STATE OF CONNECTICUT
CONNECTICUT SITING COUNCIL

DOCKET NO. 488

APPLICANTS' RESPONSES TO INTERVENOR PLANNED DEVELOPMENT ALLIANCE OF NORTHWEST CONNECTICUT, INC. INTERROGATORIES

700 MHz LTE
 Height Analysis @ -93 dBm

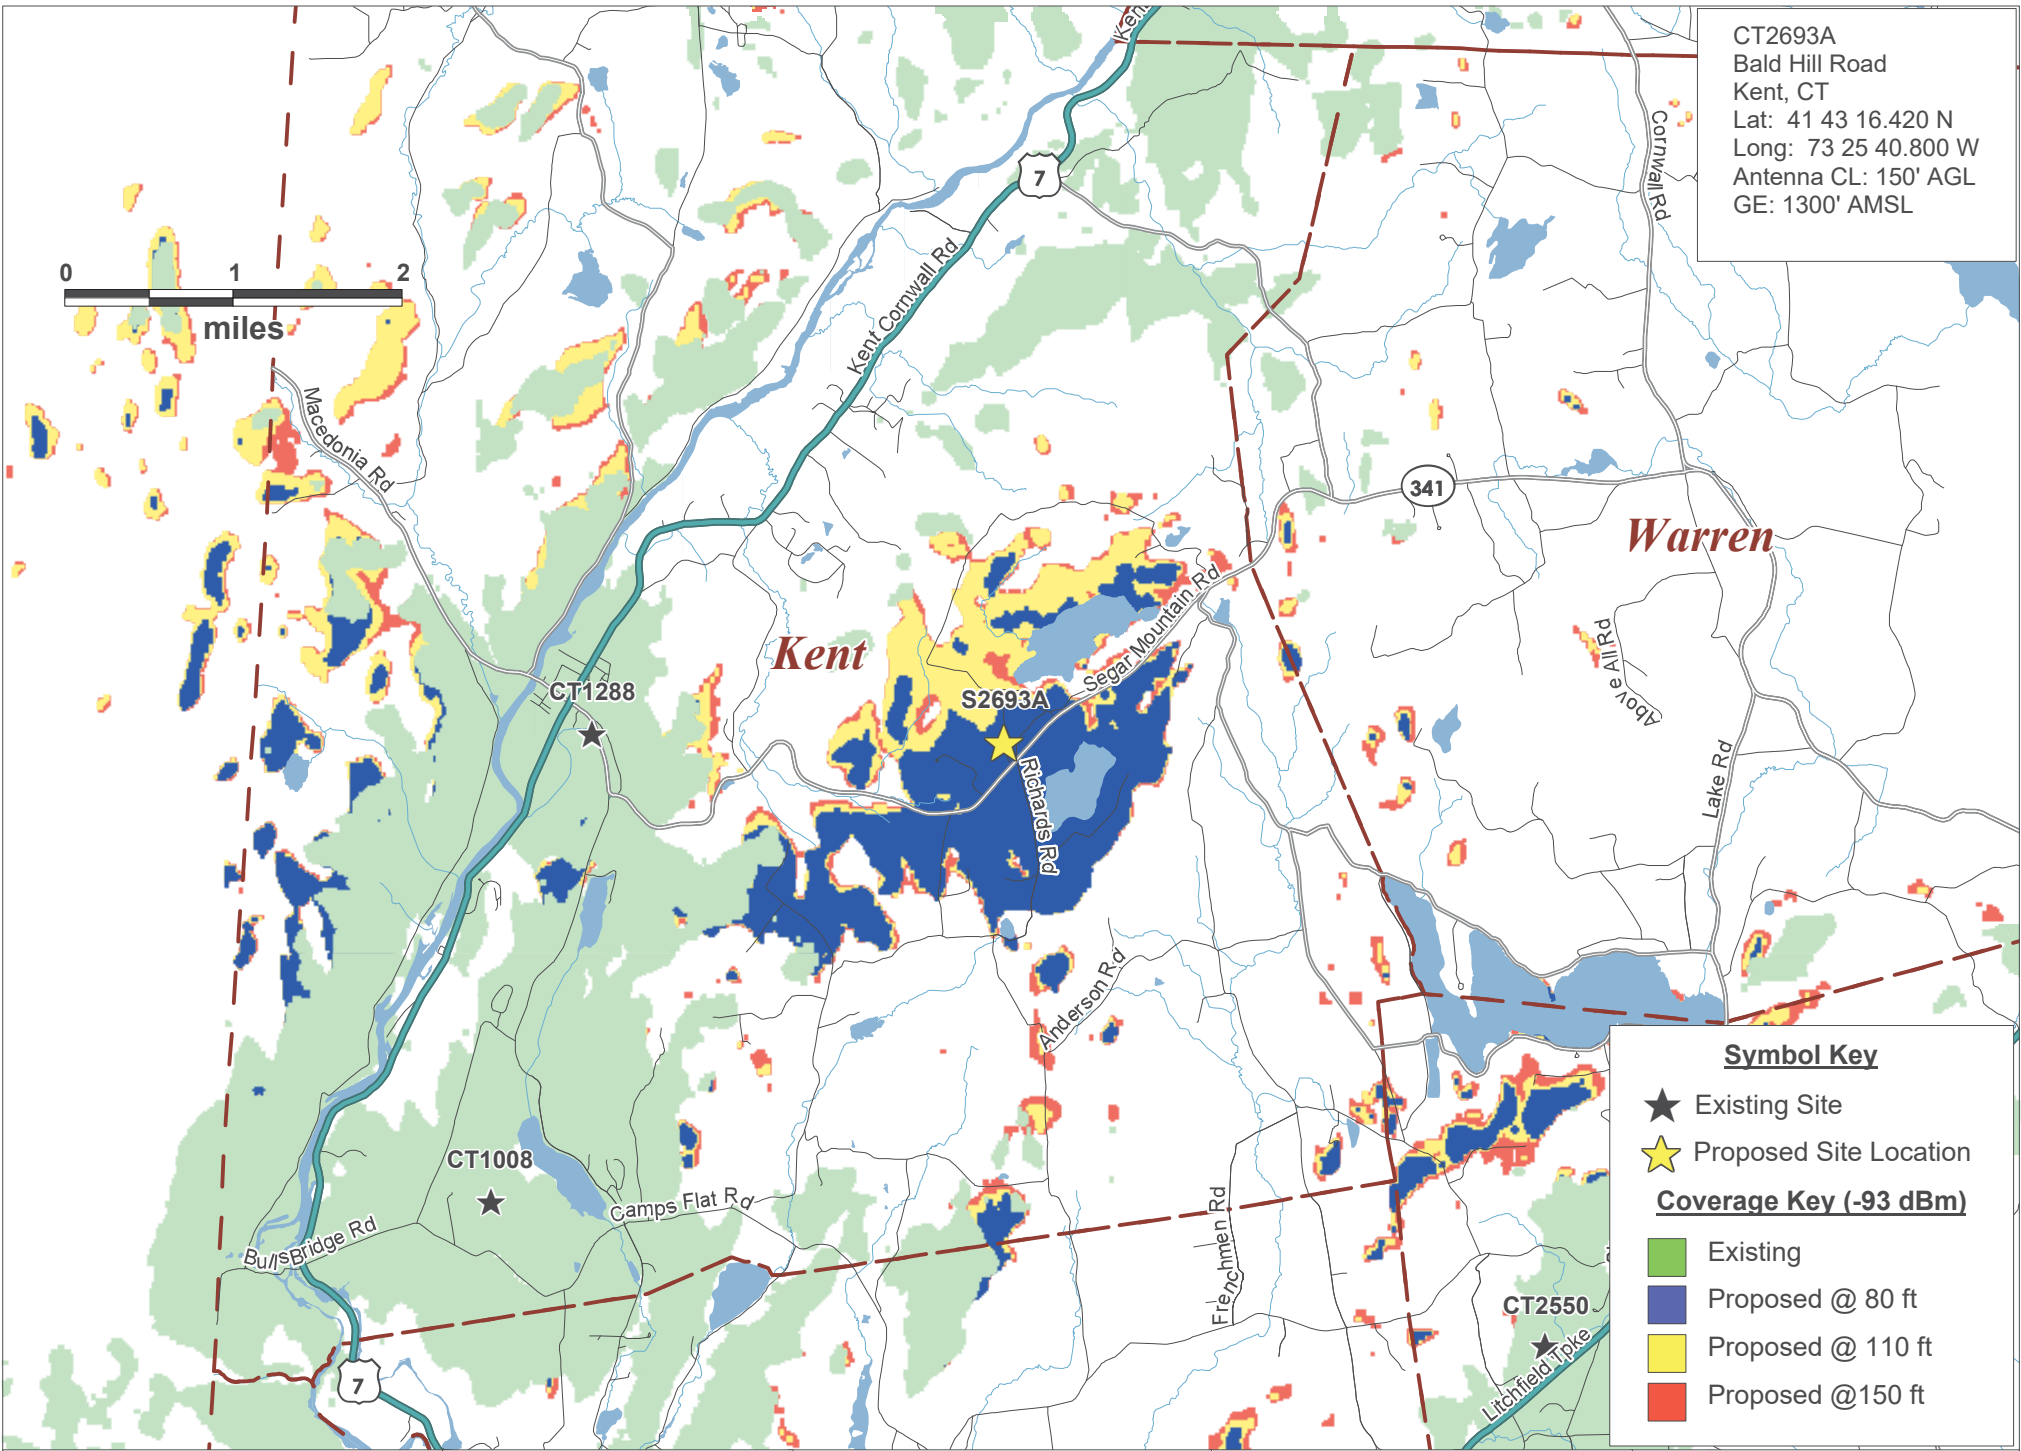
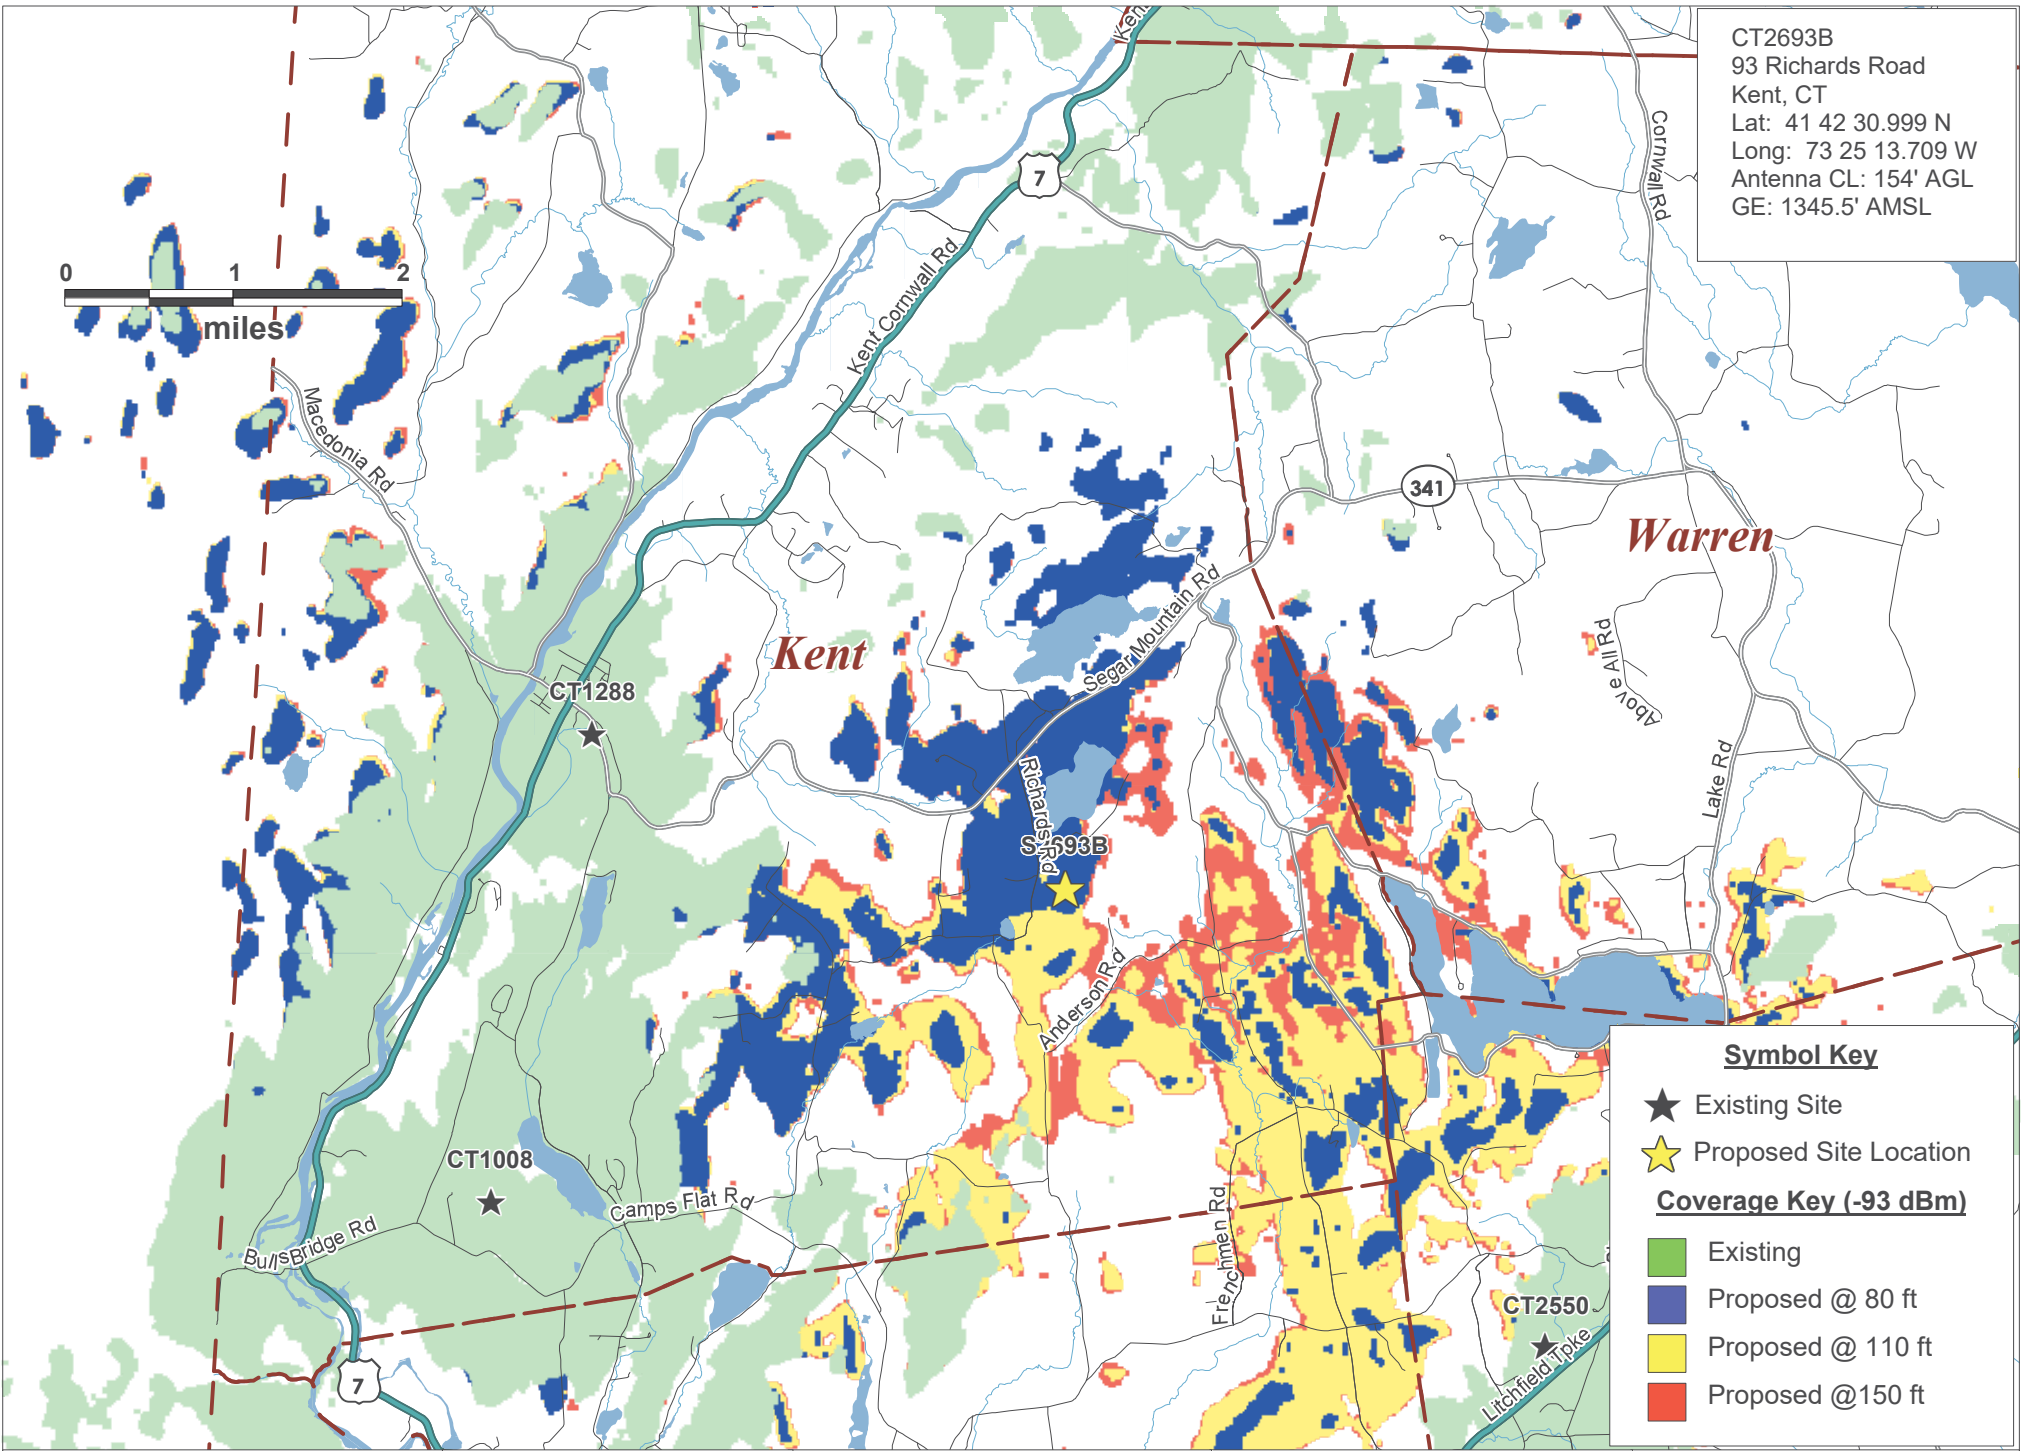
- Q10. Please provide an antenna-height coverage comparison for each proposed tower site with the proposed antenna height plus antenna heights of 80 feet and 110 feet above ground. Provide this in the form of a single map for each site, if practicable, showing the coverage differentials in multicolor overlay format. The applicant should use the same settings used to produce the coverage maps in Attachment 1 of its application.

- A10. *Provided in Attachment 3 are antenna height coverage comparisons for each of the proposed tower sites depicting coverage at antenna heights of 80 and 110 feet.*
